UNITED STATES PATENT AND TRADEMARK OFFICE

APPLICATION NO.	FILING DATE	FIRST NAMED INVENTOR	ATTORNEY DOCKET NO.	CONFIRMATION NO.
09/852,994	05/10/2001	Berthold N. Schmidt	721-1000	5821

Office Action Summary

DETAILED ACTION

FIG.2C

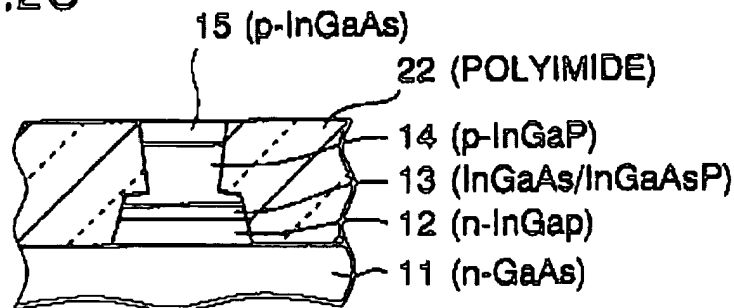
6. Claims 1, 3-5, 8 are rejected under 35 U.S.C. 102(b) as being anticipated by Arakawa et al (5,757,833). Arakawa et al discloses the claimed invention. Regarding claim 1 and its dependent claims, note figures 2c, 3c, 8 for the following features:

1. A semiconductor ridge waveguide laser diode including a semiconductor body (11) an active region (12, 13, 14) including a ridge (see col. 9 line 52, and col. 10 lines 27-30), front and back facets each with a mirror (23,24), a metallization (17) over said body and said ridge for injecting carriers into said active region (12,13,14) characterized by means (21) for limiting said injection of carriers by providing an unpumped section in the vicinity of said front and/or said back facet.

3. The laser diode according to claim 1, wherein the means for limiting the injection of carriers is an isolation layer (21) between the laser diode's active region (12, 13, 14) and the metallization (17).

4. The laser diode according to claim 3, wherein the isolation layer (21) between the laser diode's active region (12, 13, 14) and the metallization (17) is made from SiO_2 , Al_2O_3 , TiN or, preferably, SiN .

5. The laser diode according to claim 3, wherein the isolation layer (21) is extending under only a fraction of the area of the metallization (17).

FIG 2

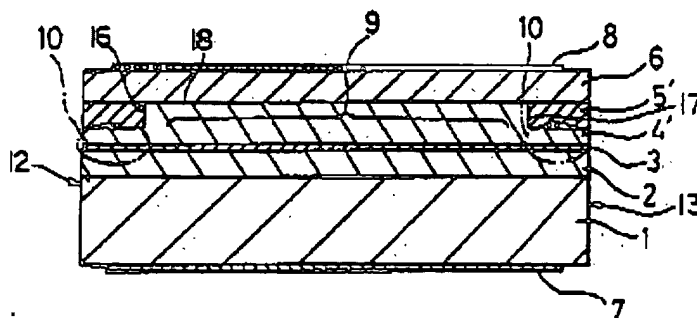
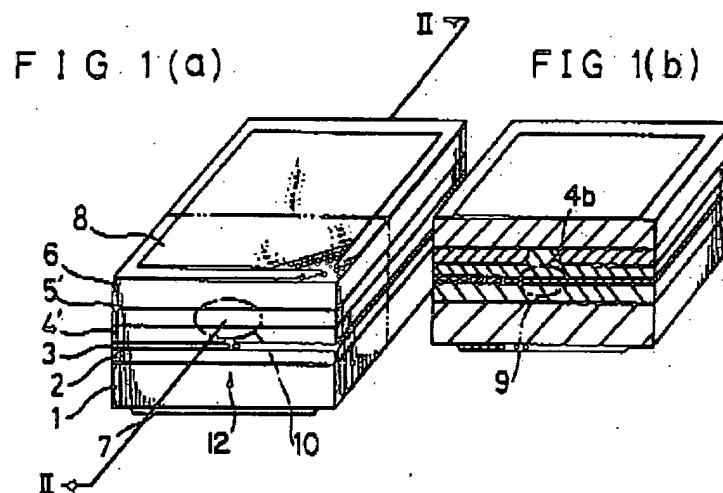
7. Claims 1-3, 5 are rejected under 35 U.S.C. 102(b) as being clearly anticipated by Mitsui et al (4,964,135). Mitsui et al clearly discloses the claimed invention.

least one of its ends as illustrated in FIG. 2. The current blocking layer 5' forms a rectifying junction with the layer 4', reducing the current injection and carrier re- 45 combination at the facets 12 and 13 compared to other laser structures.

FIG. 1

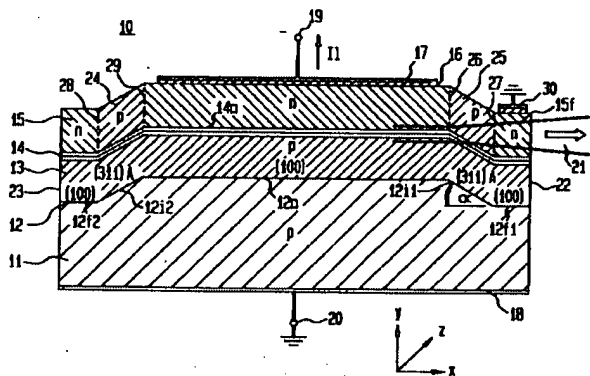
8. Claims 1-2 are rejected under 35 U.S.C. 102(b) as being clearly anticipated by Gfeller et al (5,280,535). Gfeller et al clearly discloses the claimed invention.

Still another object is to provide a laser diode of a 5
rather simple structure that can be fabricated using
conventional easy-to-control processes and that fulfills
the dual purpose of terminating the active waveguide
with a wide-bandgap zone and of preventing injected
lateral currents from flowing into the mirror facet zone. 10
